Water Right Conditions
Tracking Slip

FILE # # G-17964

SUBJECT: Scenic Waterway Interference & General/Local Surface Water
Evaluation for Deschutes Ground Water Study Area

SUBJECT: Application G- 17964 Supersedes review of _____
Date of Review(s)

G-17964: Cline Falls and Redmond Quadrangles

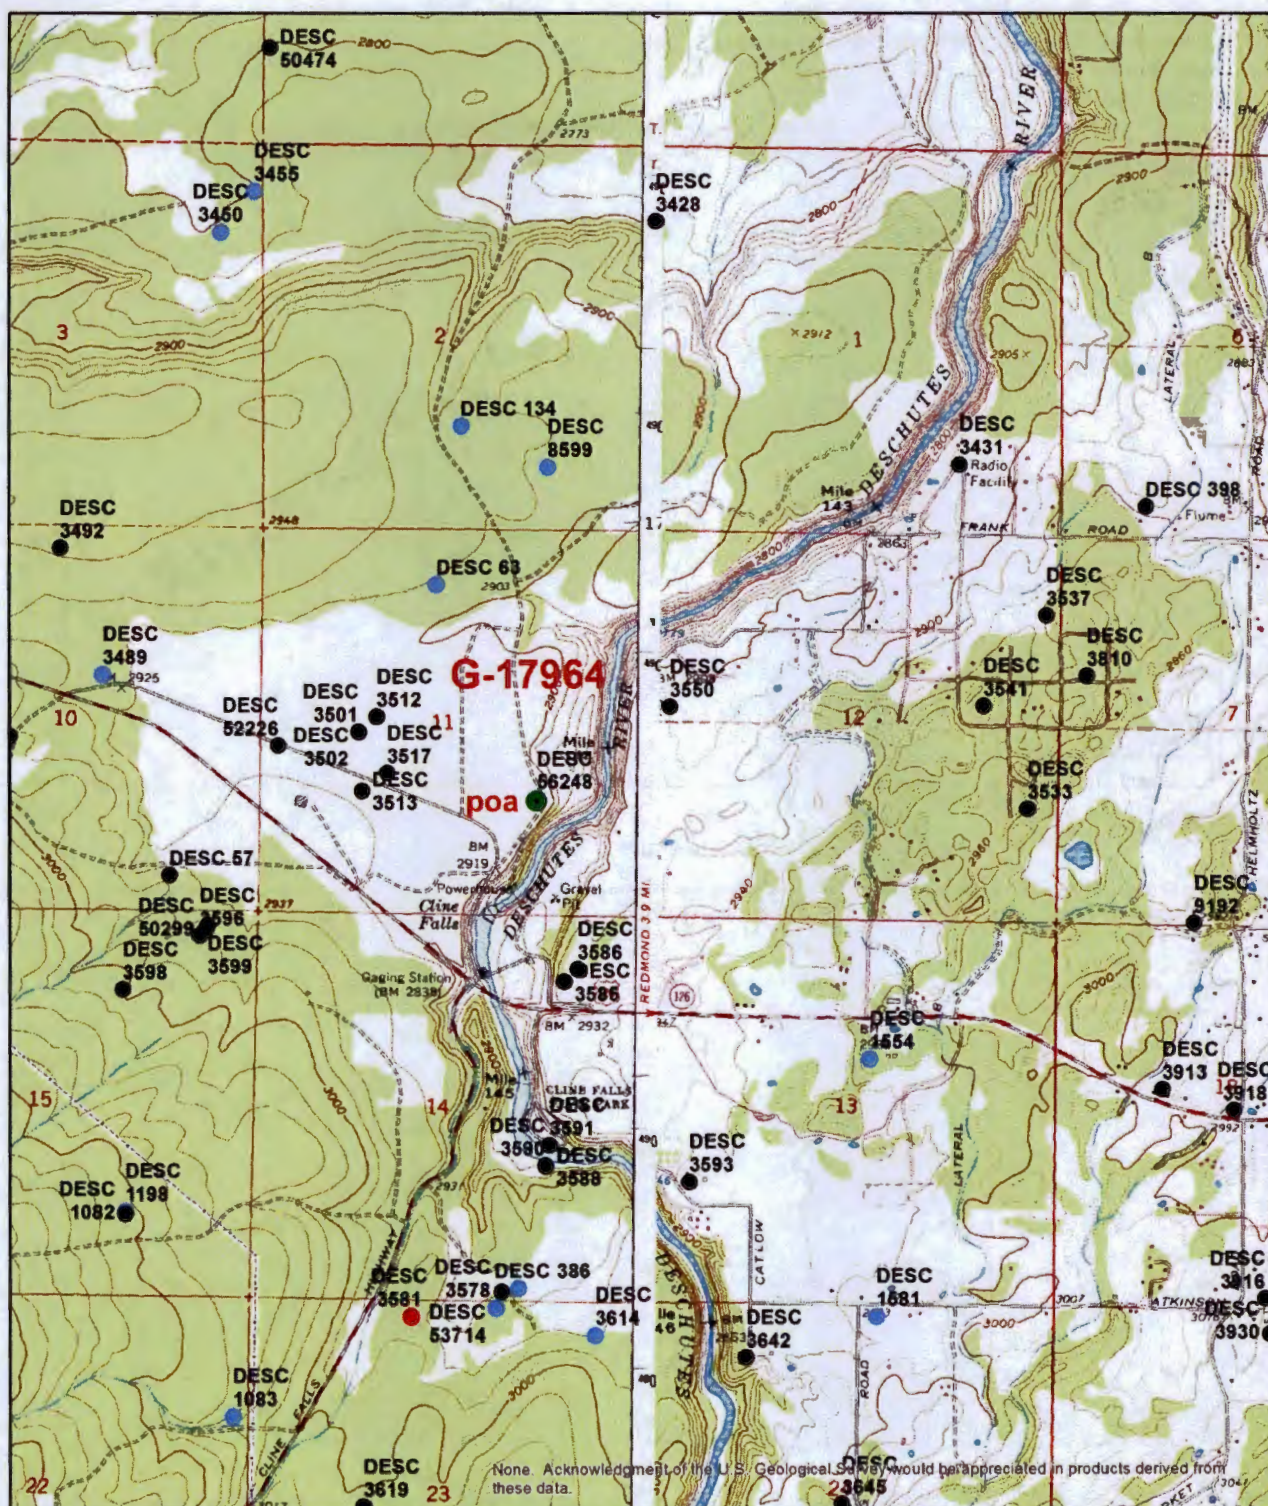
B3. Ground water availability remarks: The nearest state observation well is obs well 1317 (desc 3581), about 1.3 miles to the south. It has been monitored periodically since 1993. State observation well 1317 shows a relatively steady decline throughout the period of record. This trend is related to climate cycles, new pumping stresses, and canal lining. Since 1994, the water level has dropped about 17 feet during the period of record, mostly as a result of decreased recharge.
